# ADA Curb Ramp New Construction Inspection Form (Parallel)

Main 24952.54 Sheet No. Intersection No. Commercial  
North-South Road Name Project No. East-West Road Name

PARALLEL RAMP (PL)

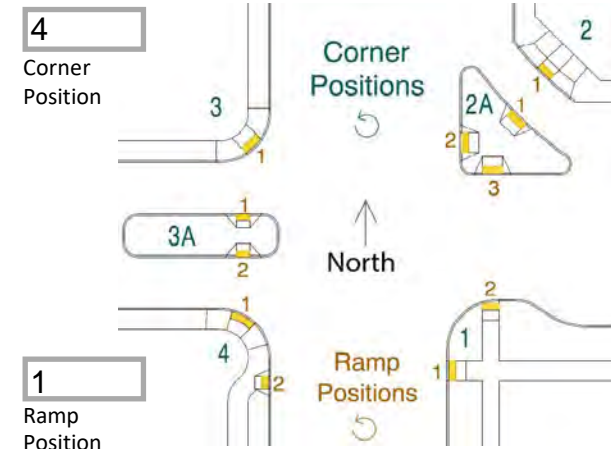
RAMP RUN 1		Pass	Fail
Running Slope 1	3.3 $\leq 2.0\%$ <input type="checkbox"/> $> 2.0\%$ <input checked="" type="checkbox"/>		
Cross Slope 1	6.1 $\leq 2.0\%$ <input type="checkbox"/> $> 2.0\%$ <input checked="" type="checkbox"/>		
Detectable Warning	N Y <input type="checkbox"/> N <input checked="" type="checkbox"/>		
Lip Height	0 $\leq 1/4"$ <input checked="" type="checkbox"/> $> 1/4"$ <input type="checkbox"/>		
Gutter Flow Slope	3 $\leq *$ <input type="checkbox"/> $> *$ <input checked="" type="checkbox"/>		
Curb Running Slope (avg)	<input type="checkbox"/> 4.96 $\leq 8.3\%$ <input checked="" type="checkbox"/> $> 8.3\%$ <input type="checkbox"/>		
Counter Slope (+/-)*2	9.3 $\leq  5.0\% $ <input checked="" type="checkbox"/> $>  5.0\% $ <input type="checkbox"/>		
Det. warning full width of ramp	N Y <input type="checkbox"/> N <input checked="" type="checkbox"/>

RAMP RUN 2		Pass	Fail
Running Slope 2	<input type="checkbox"/> $\leq 8.3\%$ <input type="checkbox"/> $> 8.3\%$ <input type="checkbox"/>		
Length 2	7.25		
Cross Slope 2	6.8 $\leq 2.0\%$ <input type="checkbox"/> $> 2.0\%$ <input checked="" type="checkbox"/>

RAMP RUN 3		Pass	Fail
Running Slope 3	9.9 $\leq 8.3\%$ <input type="checkbox"/> $> 8.3\%$ <input checked="" type="checkbox"/>		
Length 3	7.25		
Cross Slope 3	<input type="checkbox"/> $\leq 2.0\%$ <input type="checkbox"/> $> 2.0\%$ <input type="checkbox"/>

TURN SPACE		Pass	Fail
Width X	5.1 $\geq 4.0'$ <input checked="" type="checkbox"/> $< 4.0'$ <input type="checkbox"/>		
Length Y	5.0 $\geq 4.0' * 1$ <input checked="" type="checkbox"/> $< 4.0' * 1$ <input type="checkbox"/>		
Back of Ramp Obstruction (Y/N)	Y $\geq 5.0' * 1$ <input type="checkbox"/> $< 5.0' * 1$ <input type="checkbox"/>		
Slope X (Cross Slope 1)	6.1 $\leq 2.0\%$ <input type="checkbox"/> $> 2.0\%$ <input type="checkbox"/>		
Slope Y (Running Slope 1)	3.3 $\leq 2.0\%$ <input type="checkbox"/> $> 2.0\%$ <input type="checkbox"/>

MISCELLANEOUS		Pass	Fail
Clear Width (feet)	5.0 $\geq 4.0'$ <input type="checkbox"/> $< 4.0'$ <input type="checkbox"/>		
Intersection Control Type	SY Slope of Rd. 2.1		
Horizontal Gaps	No $\leq 1/2"$ <input checked="" type="checkbox"/> $> 1/2"$ <input type="checkbox"/>

Comments:  
No Td. All ramp features asphalt
